COMMUNITY DEVELOPMENT DEPARTMENT
80 Columbia Avenue ♦ Marysville, WA 98270
(360) 363-8100 ♦ (360) 651-5099 FAX

Re: SAIA – *Technical Review 1*
PA 22025

HORIZONTAL CONTROL & SITE PLAN

SAIA
 MARYSVILLE
 PREPARED FOR
 SAIA FREIGHT LTL
 CITY OF MARYSVILLE WASHINGTON

SHEET NUMBER
C4.0

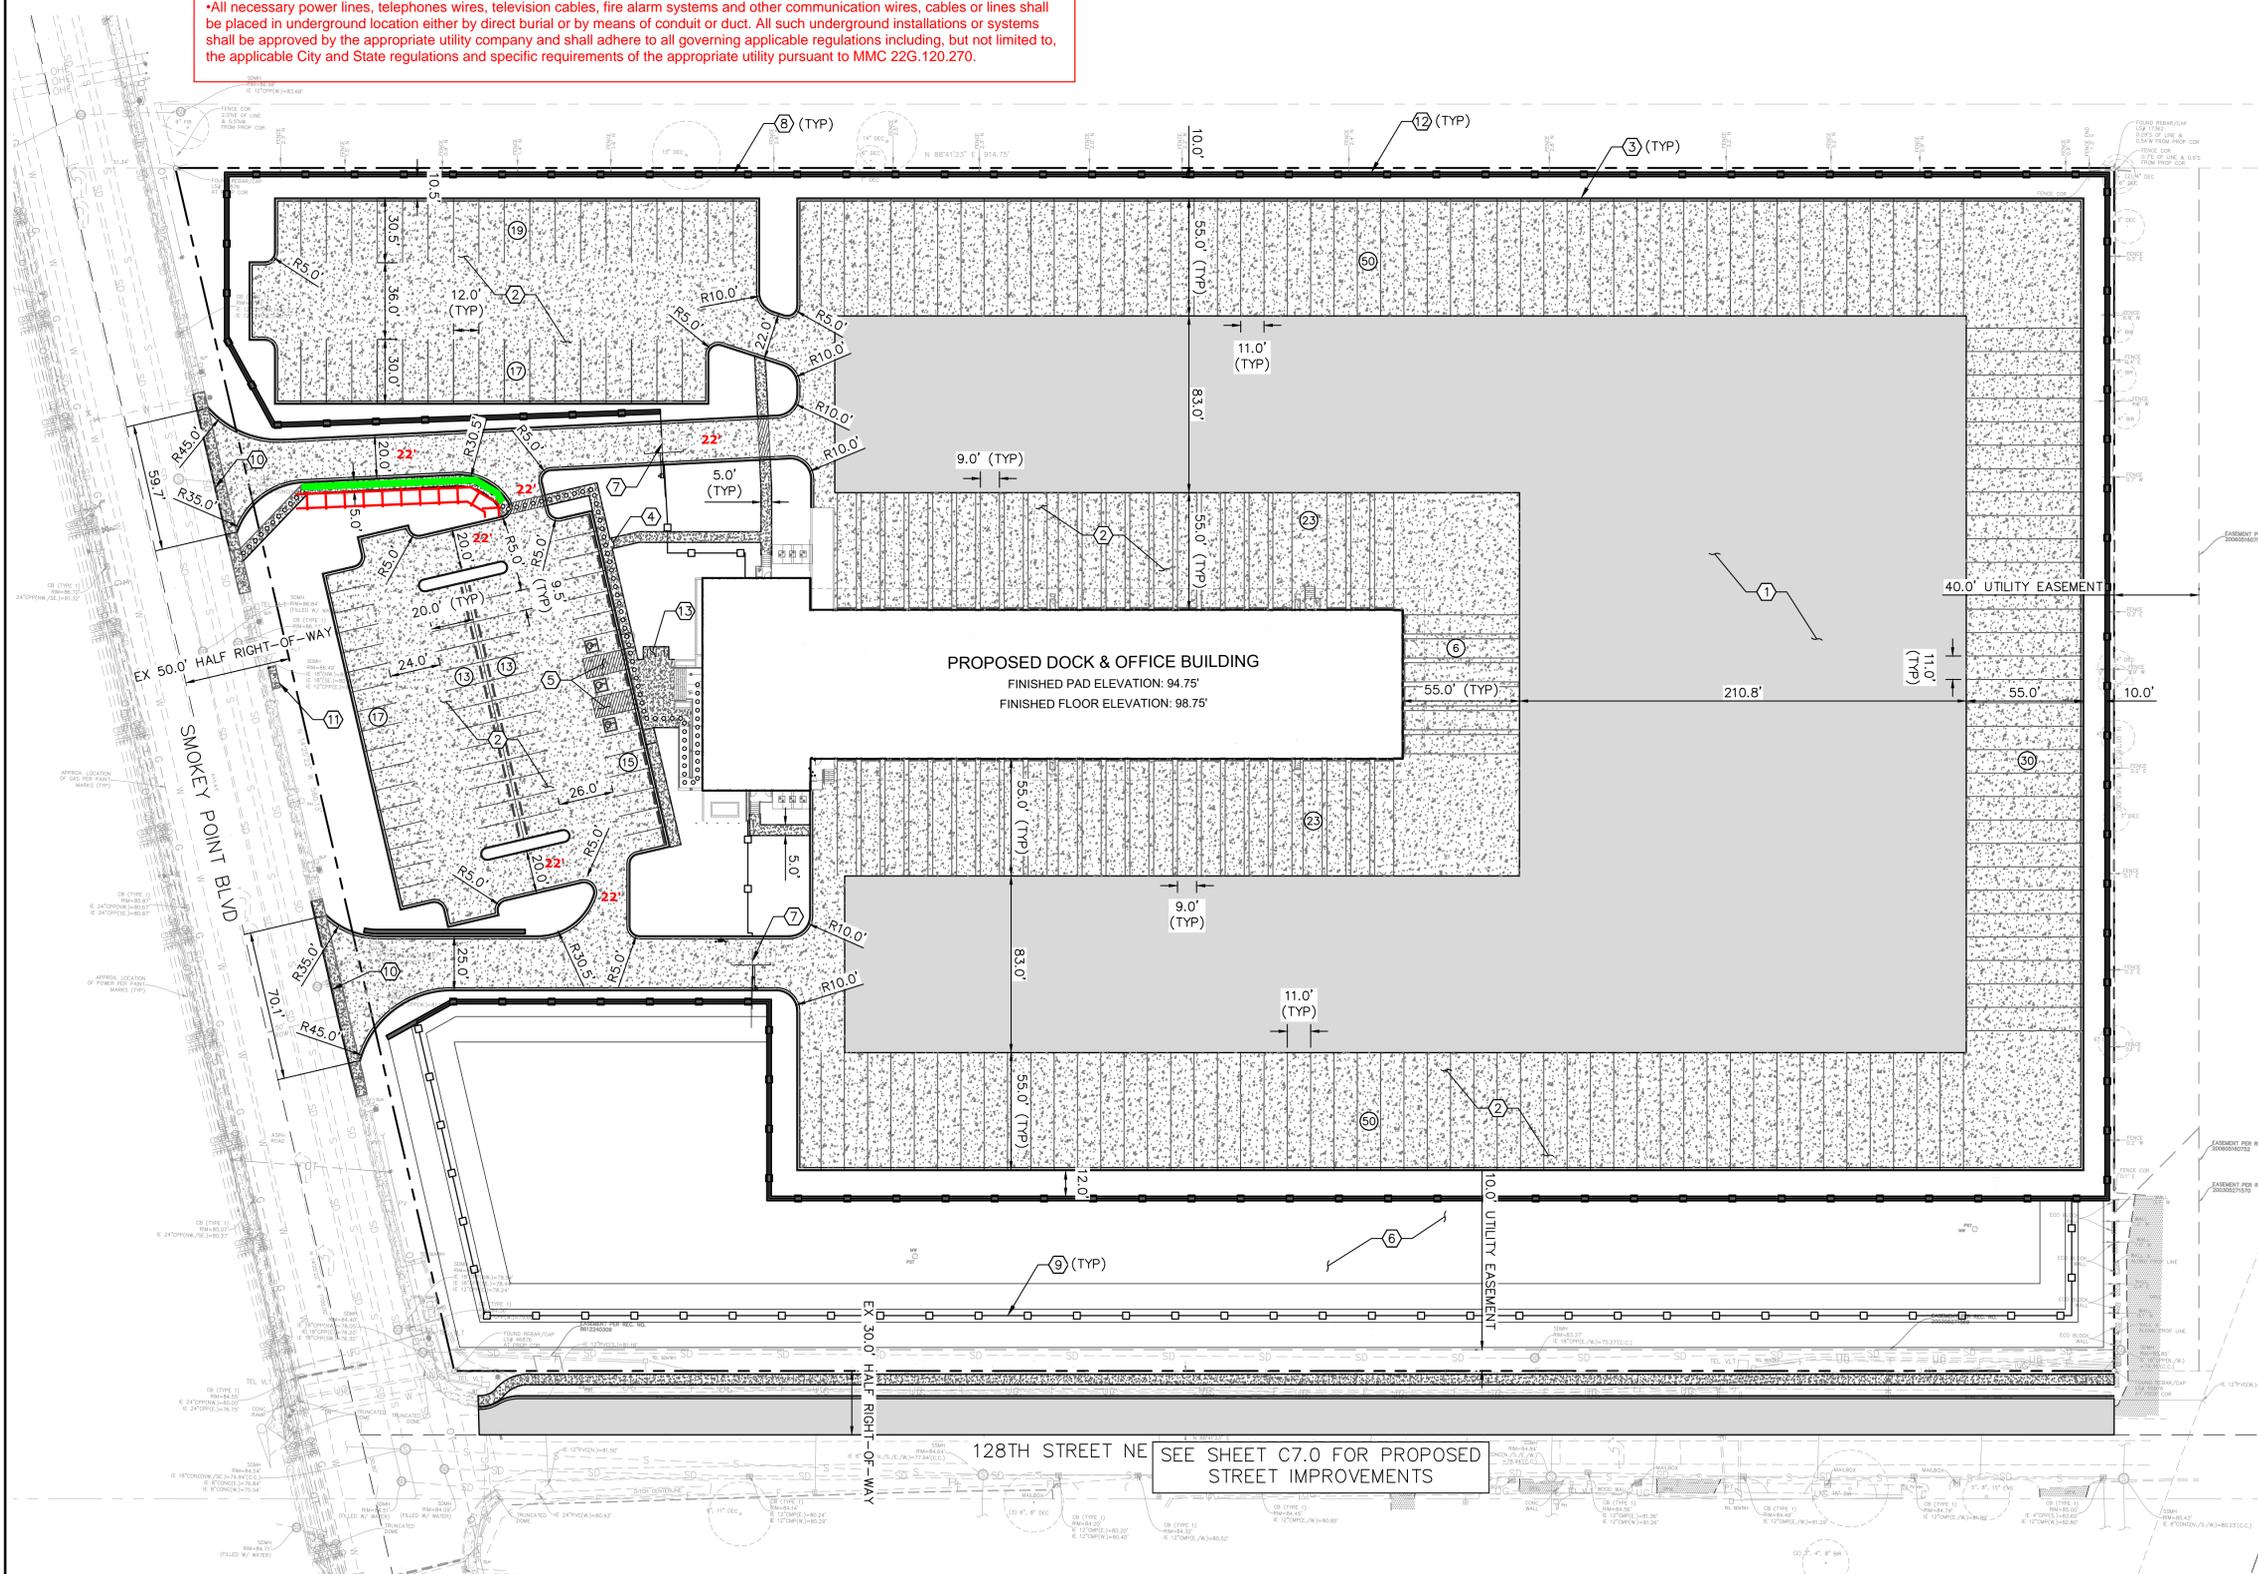
3. The attached Snohomish County Traffic Offer will need to be signed by the applicant and returned to City.
4. Amend Sheet C4.0 as follows (see attached redlines):

- a. Provide bulk & dimensional calculations outlined in [MMC 22C.020.080](#)(2) for the LI zone.
 - b. Provide required parking calculations outlined in [MMC 22C.130.030](#) Table 1.

- . Manufacturing & Industrial - 1 per 750 SF GFA plus office space requirements.
 - . Warehousing & Storage - 1 per 2,000 SF GFA plus office space requirements.

- . Office - 1 per 400 SF GFA
 - c. Provide carpool parking locations and calculations in accordance with [MMC 22C.130.030](#)(3).
 - d. Provide required bicycle parking calculations outlined in [MMC 22C.130.060](#).

- e. The minimum drive-aisle width on the northern entry way, access to the employee parking area and within the employee parking area shall be 22'.
 - f. Move the pedestrian pathway 5' south of the north drive-aisle and provide street trees and sod between the curb and pathway.

- g. Pedestrian pathways that traverse a drive aisle are required to be constructed with decorative concrete clearly denoting the pedestrian pathway. The pathways

must be universally accessible and meet ADA standards. This detail shall be required to be provided on the civil construction plans.

- h. Provide collection point for solid waste and recyclables. Contact Kristy Beedle, Solid Waste Supervisor, at 360.363.8152 or kbeedle@marysvillewa.gov, for solid waste collection area dimensional and location criteria.

Collection areas are required to be paved with concrete and screened with a minimum 6' high enclosure constructed of concrete block or brick, in addition to a 5' L1 Landscape screen.

- i. Provide details of the proposed security gates, security fencing, retaining wall fencing and detention bond fencing.
- j. Retaining walls shall be designed in accordance with [MMC 22D.050.030](#) (4). If retaining walls taller than four feet are used, as measured from the average grade, and are visible from the street or adjacent property, they shall be terraced so that no individual segment is taller than four feet; provided, that where adjacent properties are not adversely affected or the retaining wall is minor in nature, the community development director may reduce or waive these standards. Terraced walls shall be separated by a landscaping bed at least two feet in width. Alternative landscaping treatments will be considered, provided they reduce the bulk and scale of the retaining wall and enhance the streetscape or transition between properties.

This condition can likely be waived for the retaining walls on the east and south property boundaries, however the proposed retaining wall on the north property boundary is likely to impact the neighboring private property.
